ADDENDUM NO. 4

Reference: Holland Centennial Commons
Dixie State College – St. George, Utah
DFCM Project No. 06297640

ADDENDUM No. 5

**Dixie State College of Utah
Holland Centennial Commons
Addendum #5
Civil Drawings and Specifications**

ADD
MH1.01

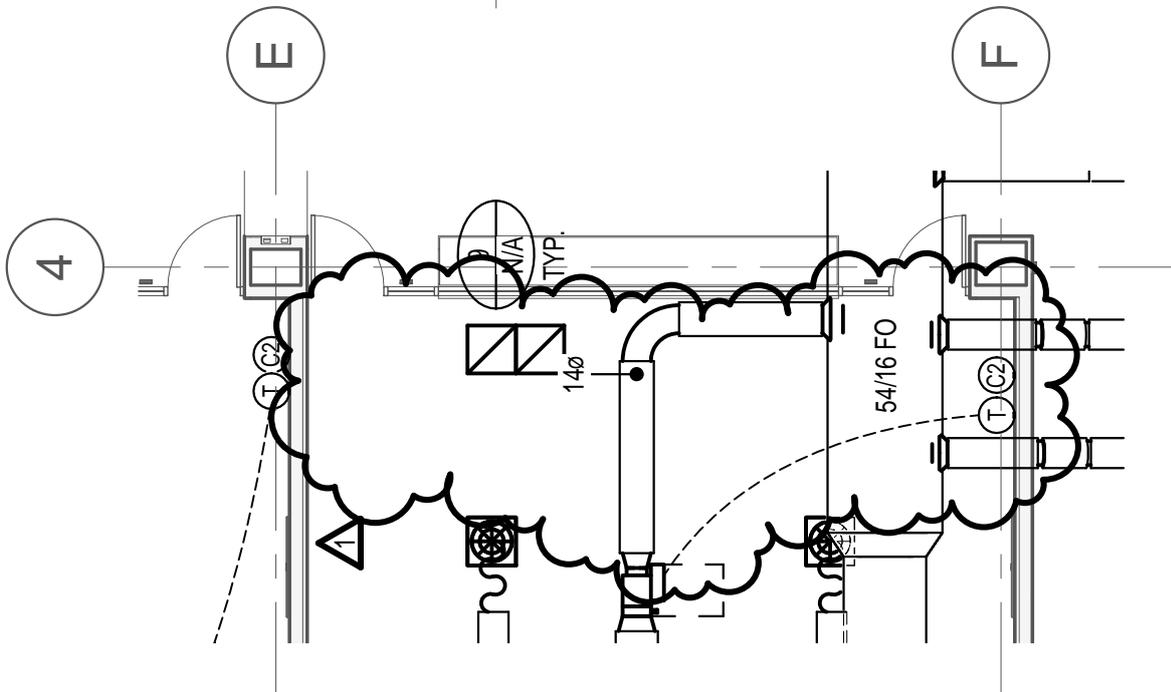
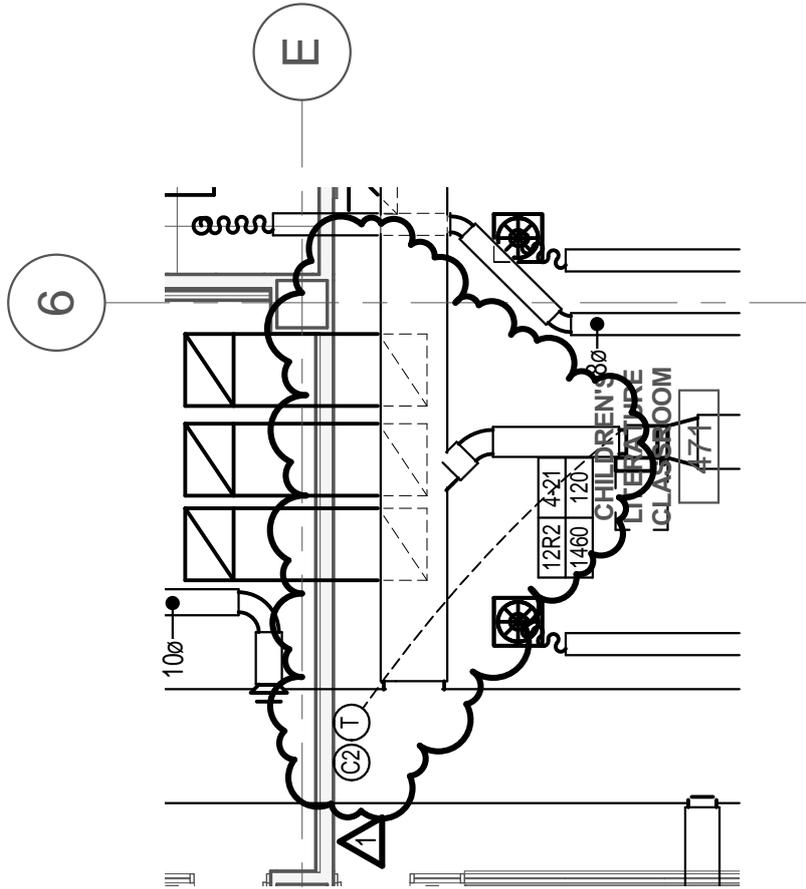
ADDENDUM #5
RELOCATE THERMOSTAT AND CO2 SENSOR

EP101-R1-1

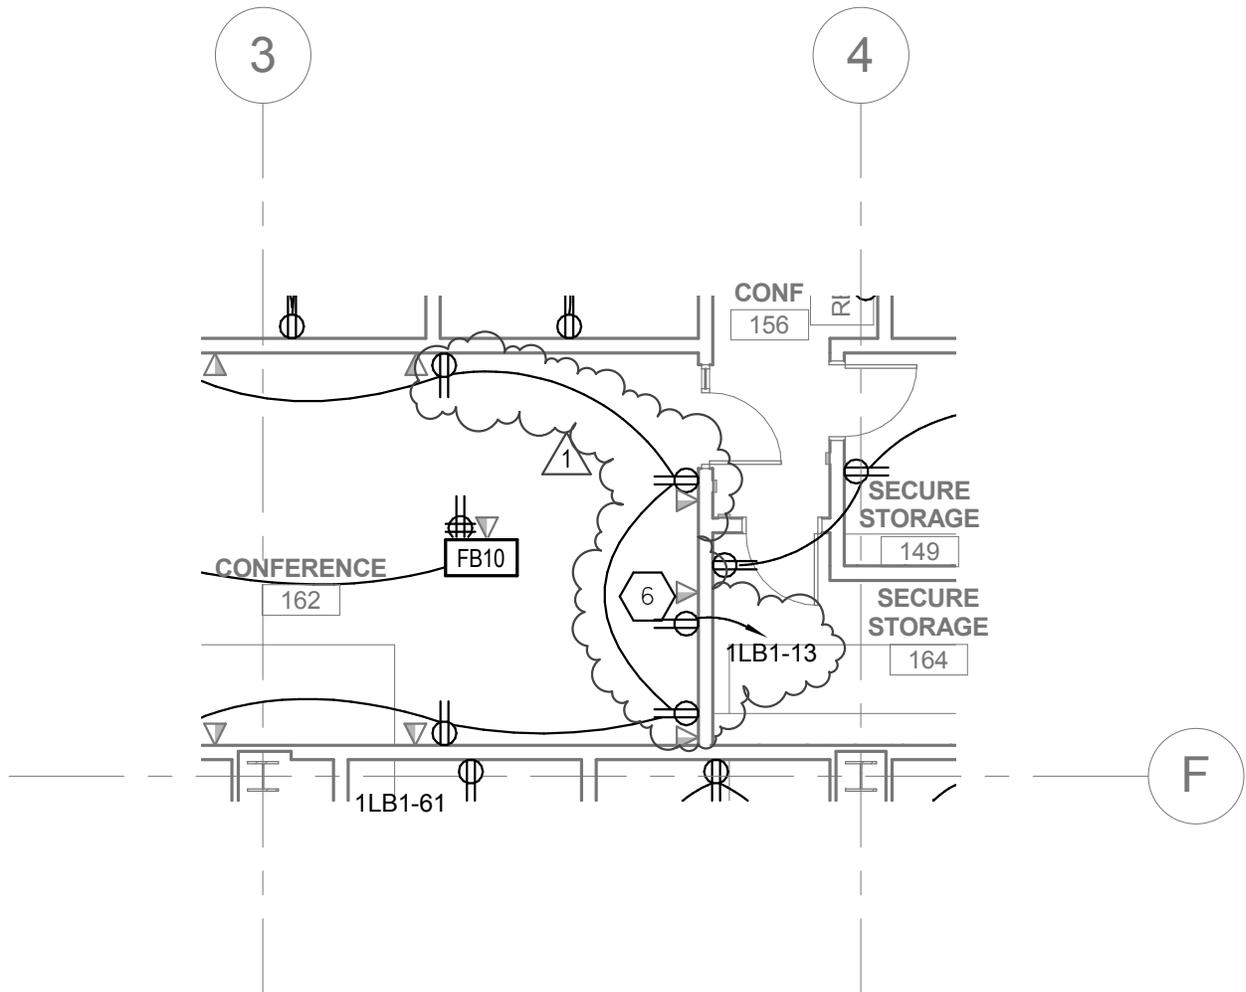
1. Delete keynote #2 symbols from Open office 195.
2. Circuit receptacles in Circulation 161B to 1LB1-66.
3. Remove “typ” text from keynote #6 at corridor monitor near grids B.5 and 5. Circuit this receptacle to 1LA1-65 as shown on attached revised drawing EP101-R1-1.
4. Circuit corridor receptacles in Circulation 127 corridors to 1LA1-33 as shown on attached revised drawing EP101-R1-1.
5. Change floor box near E and 5 in Open Offices 161 from FB6 to FB5. All FB5 floor boxes in Open offices 161 shall be circuited to 1LB1-32,34,36 and 38 for future systems furniture connections.
6. Circuit monitor in circulation 155 near grids E.5 and 2 to 1LB1-64.
7. Circuit under counter refrigerator in Conference 162 to 1LB1-65.
8. Revise circuiting at east wall of Conference 162 as shown on attached revised drawing EP101-R1-2.
9. Circuit microwave oven in Conference 156 to 1LB1-62

EP102M-R1

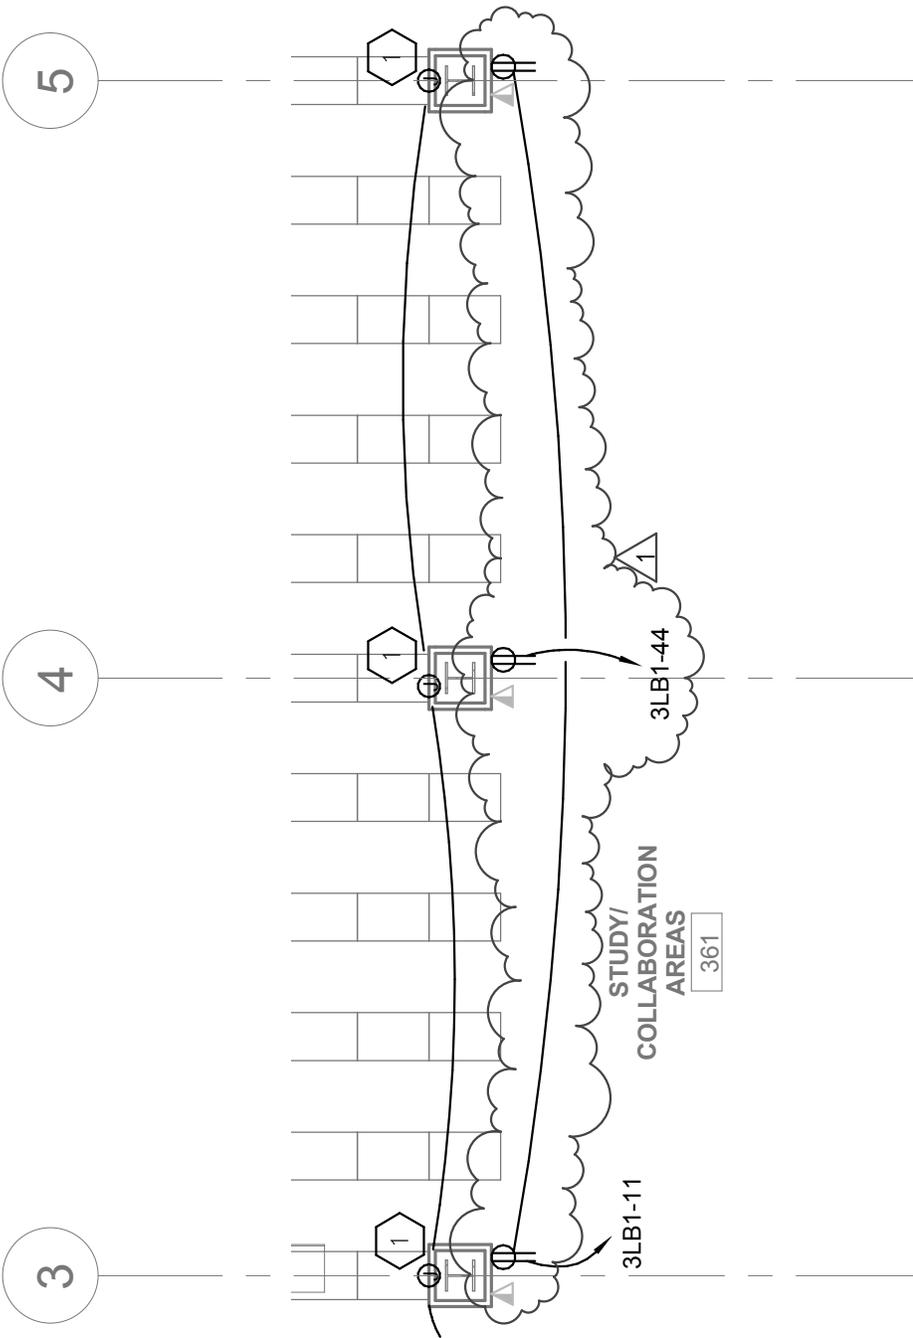
1. Re-circuit receptacles along gridline B from grid 2 to 4 as shown on attached revised drawing EP102M-R1.
2. Refer to keynote #2 and table top raceway along gridline 2 from C to E.6 and gridline 5 from C.2 to H. Table top surface raceway and receptacles extend from the column where they are fed to the next column, wall or end of the work surface even where hatching of symbol is incomplete on drawings.

EP103-R1-1

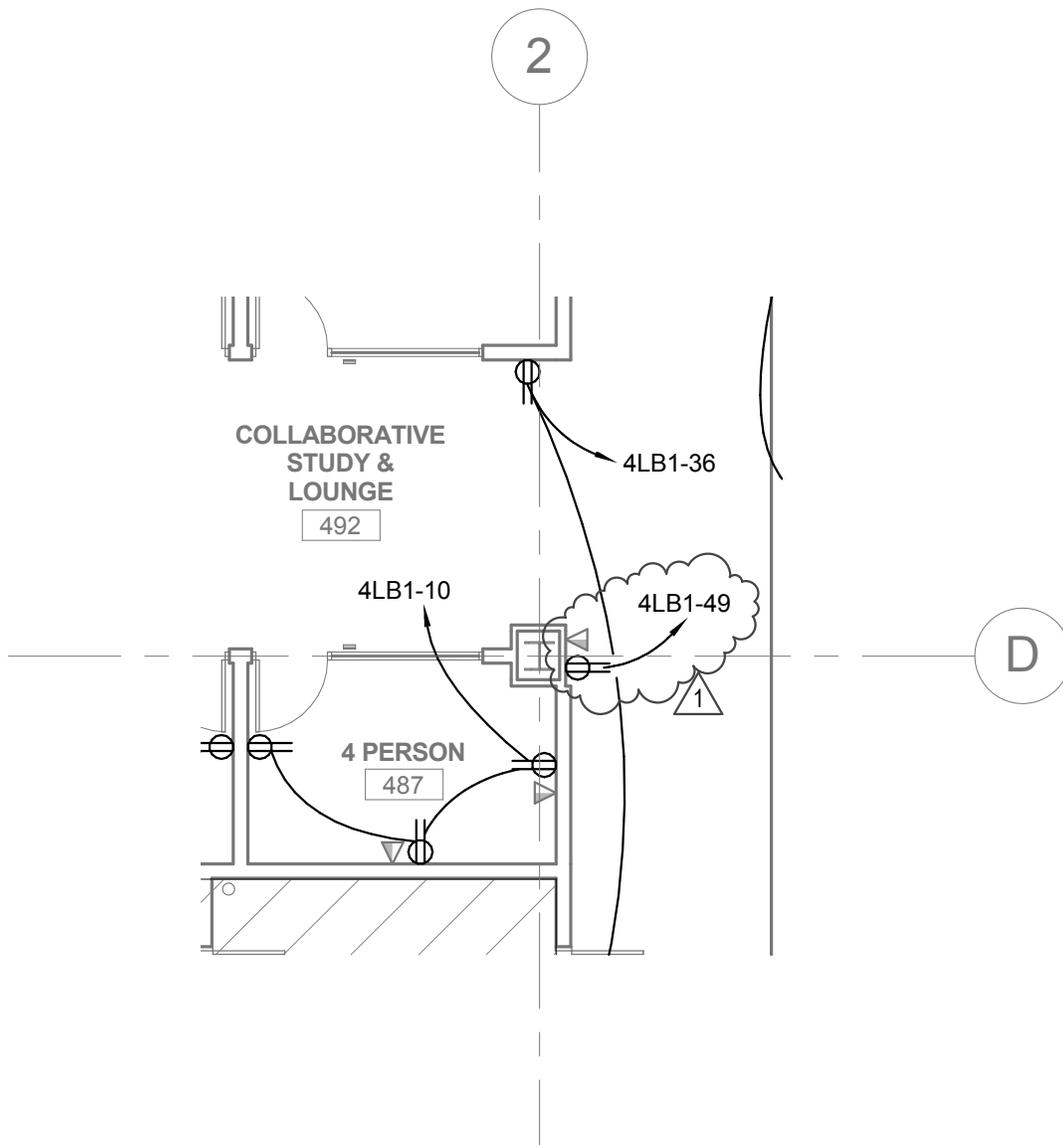
1. Circuit uncircuited poke-thrus in Reading Room 330 to 3LA1-65.
2. Change keynote #6 in Classroom 340 from #6 to #5 and circuit associated projector to 3LA1-17.
3. Delete Keynote #6 text from. Keynote 6 is unused.
4. Re-circuit receptacles along gridline F from grid 3 to 5 as shown on attached revised drawing EP103-R1-1.

EP104-R1-1

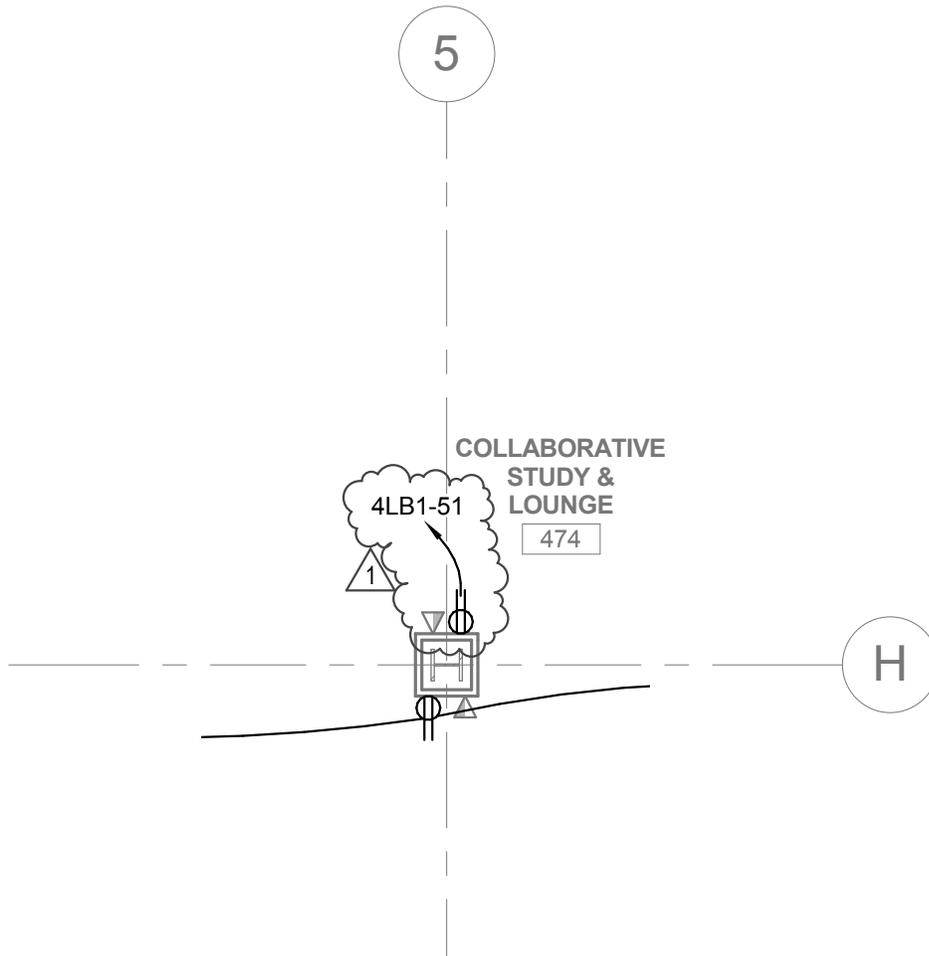
1. Refer to circuit 4LA1-77,75 home run in the southwest corner of Tutoring 434. Circuit the (4) receptacles shown on north exterior wall to breaker #75 and the (3) receptacles on the south wall to circuit breaker #77.
2. Add Receptacle and voice/data outlet near grids D and 2 as shown on attached revised drawing EP104-R1-1. Circuit receptacle to 4LB1-49.
3. Add Receptacle and voice/data outlet near grids H and 5 as shown on attached revised drawing EP104-R1-2. Circuit receptacle to 4LB1-51.
4. Change keynote #4 to #3 at projectors at gridlines F and 3.5 and at gridlines F and 5.5.
5. All system furniture power junction boxes (SP) in Adjunct Faculty Open Office 457A shall be circuited to 4LA1-13,15,17 for future systems furniture connections.

PROJECT	HOLLAND CENTENNIAL COMMONS	
SHEET TITLE	LEVEL 5 POWER PLAN	
SCALE	1/8" = 1'-0"	EP105-R1-1

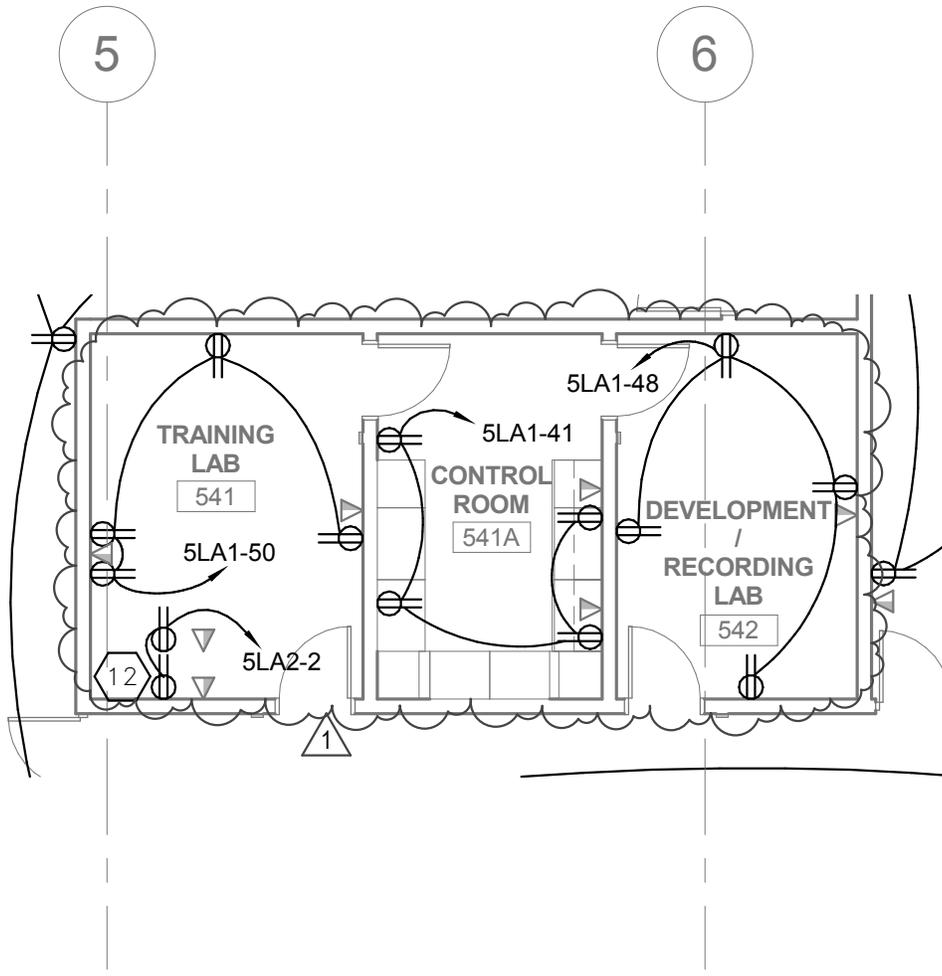
1. Delete junction box without keynote #9 near gridlines A.5 and 8 in Zion room 537.
2. Revise circuiting in Training Lab 541, Control Room 541A and Recording Lab 542 as shown on attached revised drawing EP105-R1-2.
3. Add keynote #5 to uncircuited receptacle near gridlines D and 6 in Conference 560. Circuit receptacle to 5LA1-39.
4. Move (2) receptacles and voice data outlet in middle of Leaders Reception 571 to desk in the same room. Locate in the north/south portion of desk.
5. Add Receptacle and voice/data outlet near grids D.6 and 3 as shown on attached revised drawing EP105-R1-1. Circuit receptacle to 5LB1-61.
